TO: Service Locations

FROM: Service Systems Development

SUBJECT: **GHG17 Heavy Duty Engine Platform 1-BOX™ Aftertreatment System (ATS) Wire Harness**

Figure 1 – GHG17 1-BOX™ ATS Wire Harness

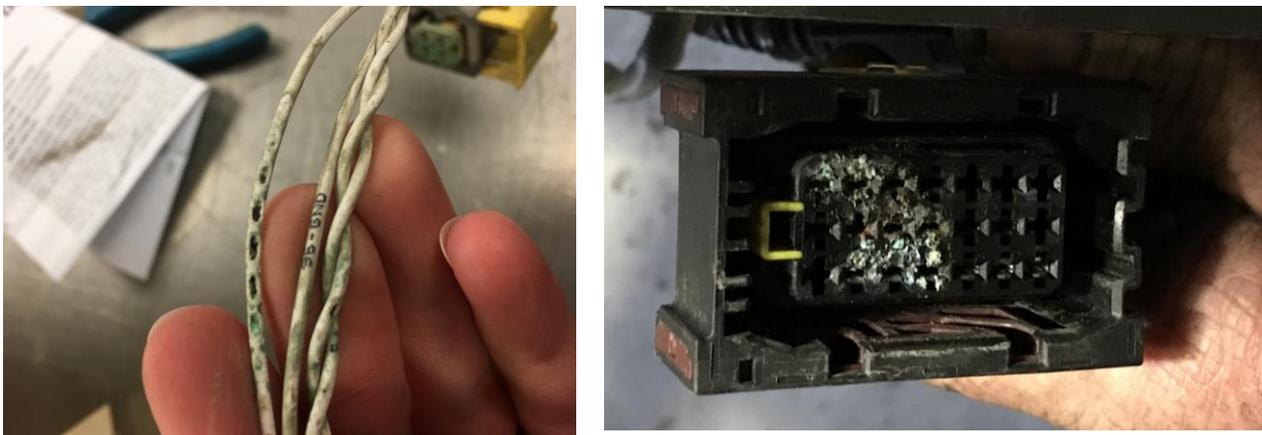
For GHG17, the main Aftertreatment Control Module (ACM) harness shifted from a Daimler Trucks North America (or vehicle OEM) part to a Detroit™ part. There are two main issues with the 1-BOX™ ATS harness. Reference Figure 1.

- Harness shows chaffing on the branch to the 21-pin connector and Soot Sensor
- Harness and ACM show corrosion at the 21-pin connector

Anti-chaffing tape should be applied to the current ATS harness, or to a new replacement harness if it does not have the tape. See the Repair Procedure section for instructions on installing the tape.

Figure 7 – Wire Harness Inspection

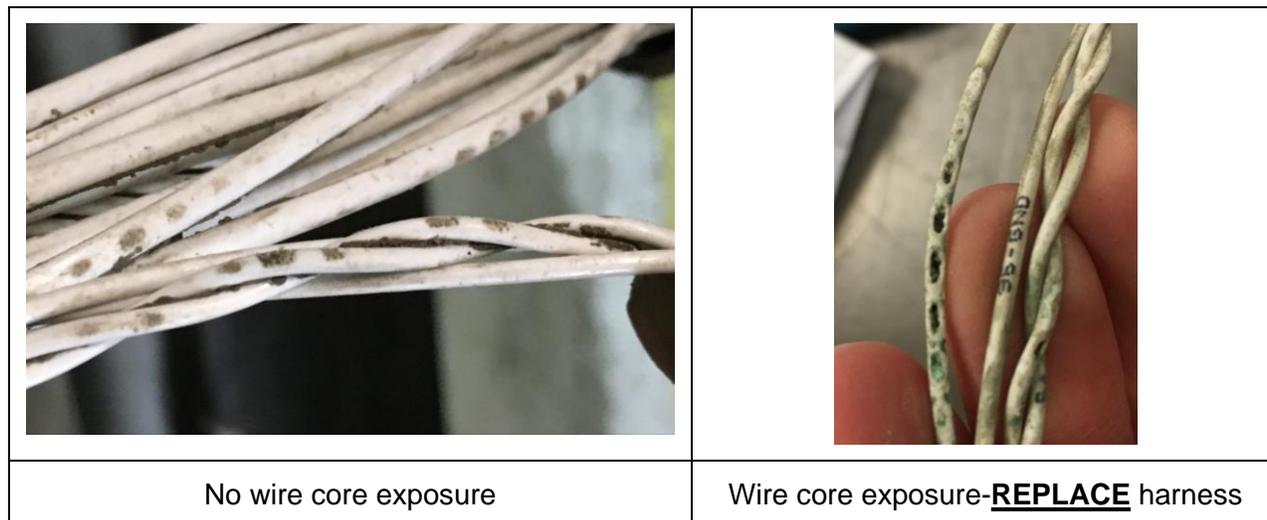
9. Inspect all exposed wires for damage or corrosion, looking carefully for wire insulation that has worn through, exposing the wire core. Is there exposed wire core? Reference Figure 7.
- Yes; replace the ATS harness. Reference the removal and installation sections for the 1-BOX™ Aftertreatment Harness in the *GHG17 Heavy Duty Workshop Manual* (DDC-SVC-MAN-0190). Instructions for adding anti-chaffing tape are further below. Go to step 11.
 - No; go to step 10.

Figure 8 – ATS Harness 21-pin and 120-pin Connector Inspection

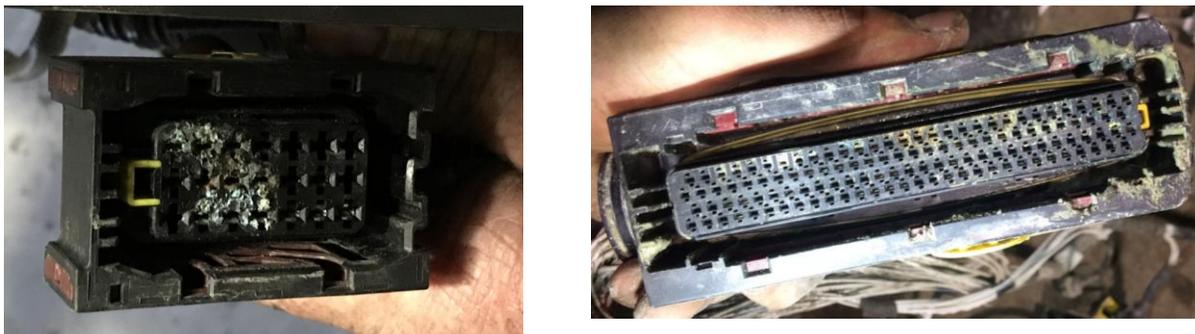
10. Inspect the ATS harness 21-pin and 120-pin connectors for excessive corrosion. Reference Figure 8. Is excessive corrosion present at one or both connectors?
- Yes; replace the ATS harness. Reference the removal and installation sections for the 1-BOX™ Aftertreatment Harness in the *GHG17 Heavy Duty Workshop Manual* (DDC-SVC-MAN-0190). Instructions for adding anti-chaffing tape are further below.
 - No; the harness will be reused.
